ENVIRONMENTAL COMMISSION MOTION 20160323 008a

Subject: Eliza Springs Outlet Daylighting (as revision to Barton Springs General Grounds Improvements) SPC-2012-0104D

SUBJECT: SOS and Other Code Amendments for Eliza Springs Outlet Daylighting Project
SP-2012-0104D

Planting Plan Cross Section

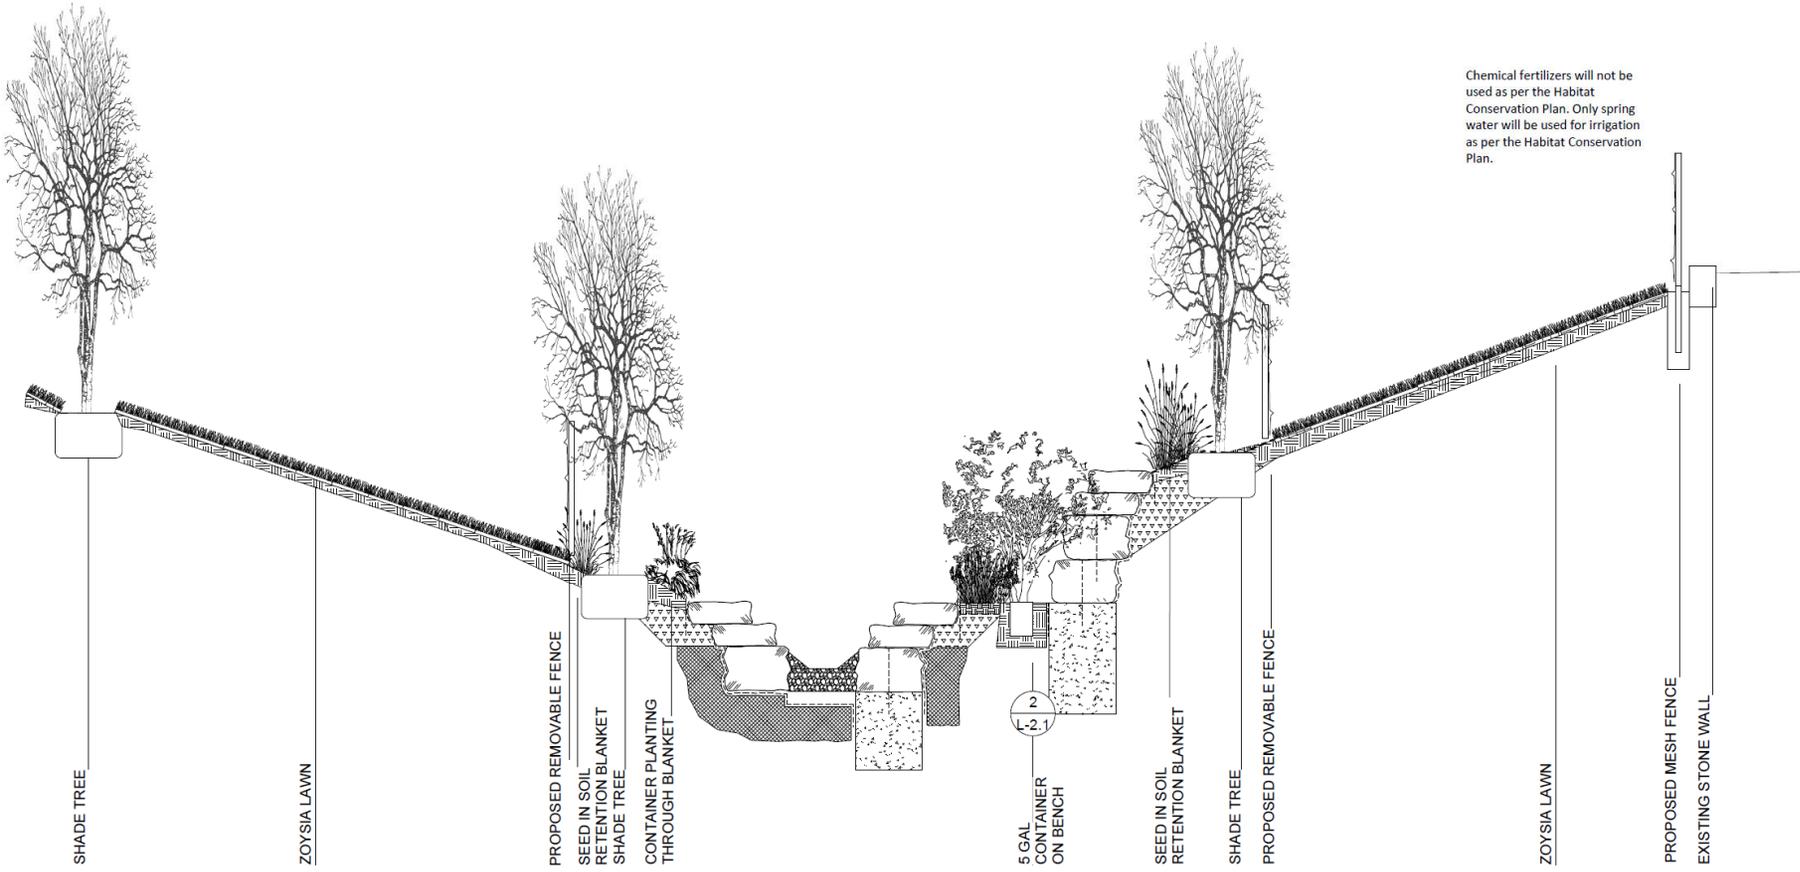
2. Consider reducing density of trees with a minimum of 25' of spacing and consider removing bald cypress and consider more understory as a substitute for trees
